PCN# : P677AAB
Issue Date : Jul. 22, 2016

Information Only Notification

Description of Change (From) :

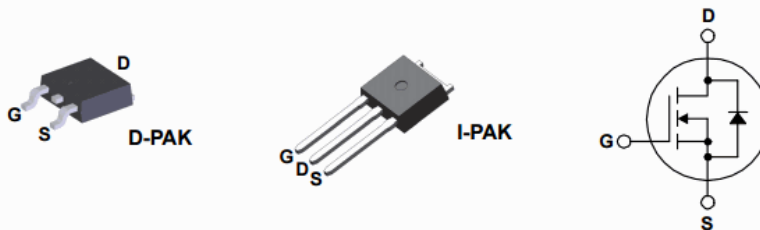
- 1) Page 1, 3D drawing of D-PAK (TO-252) package
- 2) Page 1, No Pin numbers on D-PAK package

Description of Change (To) :

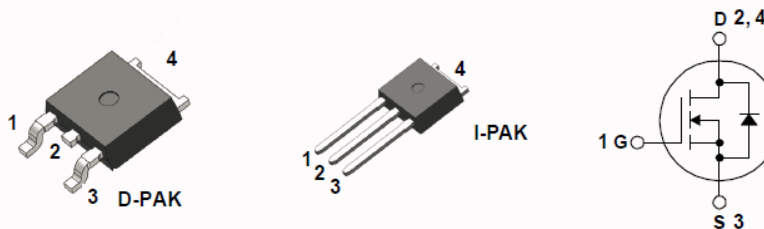
- 1) Page 1, updated the 3D drawing of D-PAK (TO-252) package to latest graphic
- 2) Page 1, added Pin numbers to D-PAK package drawing
